**GEORGIA POWER COMPANY
INSERVICE TEST PROGRAM**

**VOGTLE ELECTRIC GENERATING PLANT
UNIT 2**

ISI-P-016

Revision 5 Summary of Changes

PUMP INSERVICE TESTING LOOP FOR CENTRIFUGAL CHARGING PUMP 2-1208-P6-002

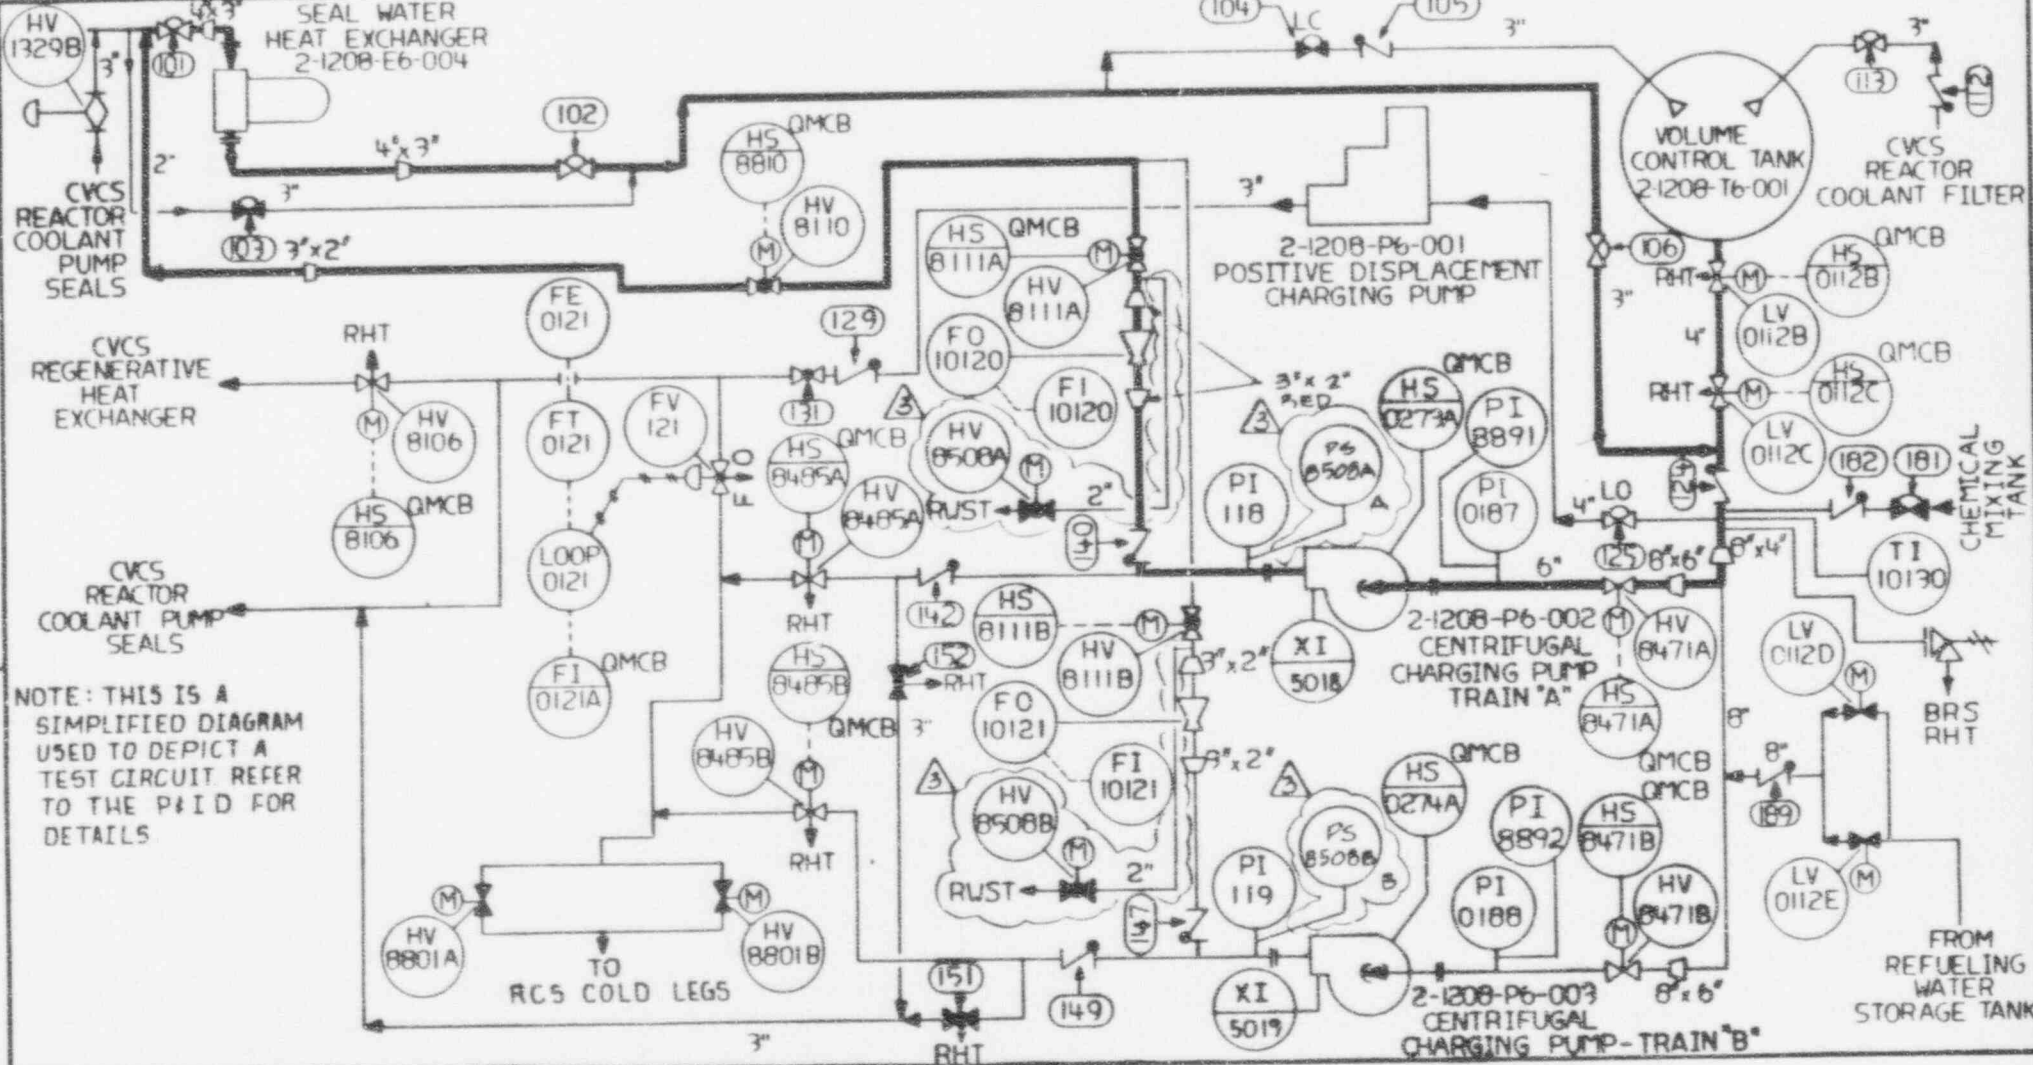
REV.	DATE	BY	CHK'D	DESCRIPTION	APPR. 1	APPR. 2	APPR. 3	APPR. 4	APPR. 5	REMARKS
0	9-5-87	BGL	WS	ISSUED FOR P&I						
1	1-26-88	CL	RZB	UPDATED TO REV 15 OF 2X4081G-208C						
2	4-19-89	TW	JMA	ADDED PI-8891 & PI-8892						
3	12-6-93	WIS	DAG	RELOCATED 2" BRANCH CONNS. AND ADDED PS8508A&B

PUMP INSERVICE TESTING LOOP FOR CENTRIFUGAL CHARGING PUMP 2-1208-P6-003

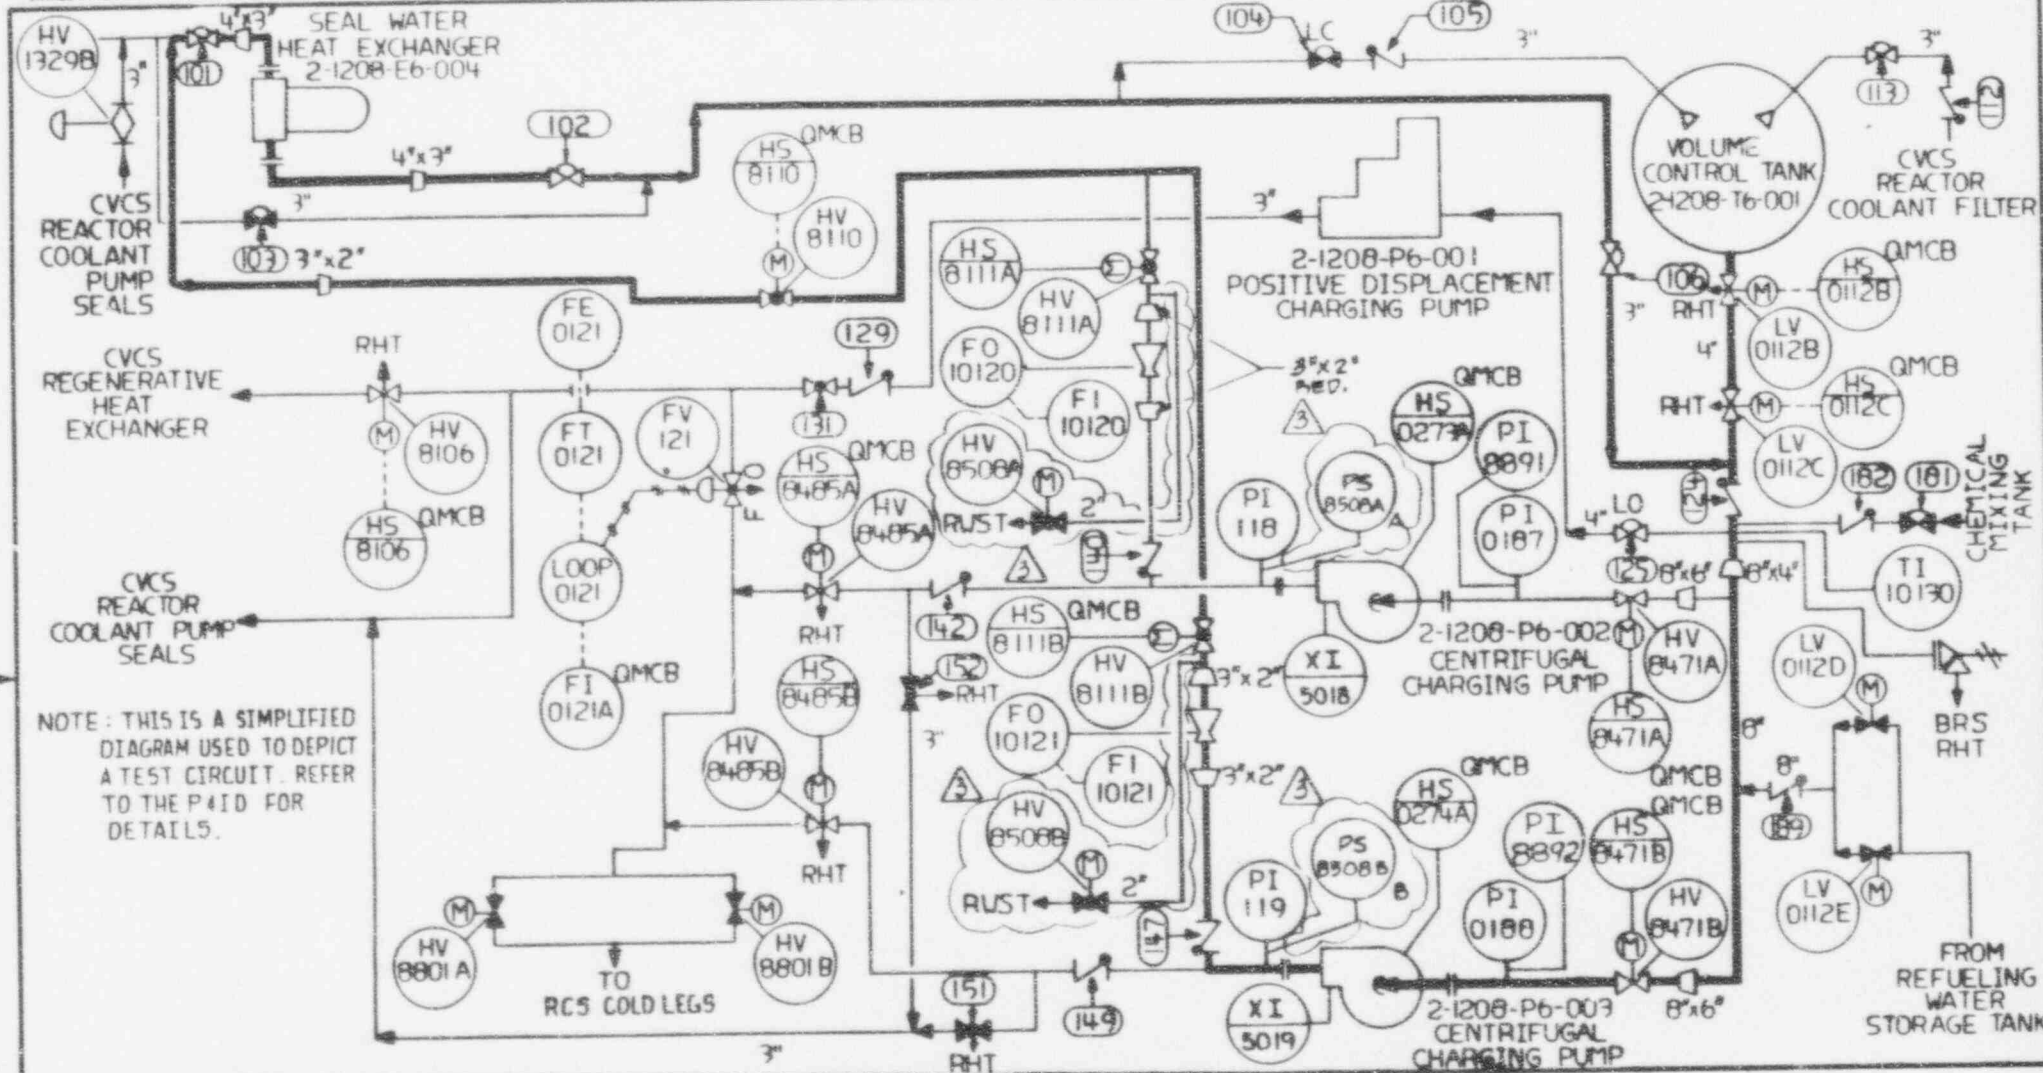
REV.	DATE	BY	CHK'D	DESCRIPTION	APPR. 1	APPR. 2	APPR. 3	APPR. 4	APPR. 5	REMARKS
0	9-5-84	AM	WZ	ISSUED FOR PST						
1	1-26-88	CL	WZ	UPDATED TO REV 15 OF 2XAD0116-2						
2	4-19-89	WZ	JMA	ADDED PI-8891 & PI-8892						
3	12-2-93	WZ	DRG	RELOCATED 2 BRANCH CONNS. ADDED PS 8508B & A
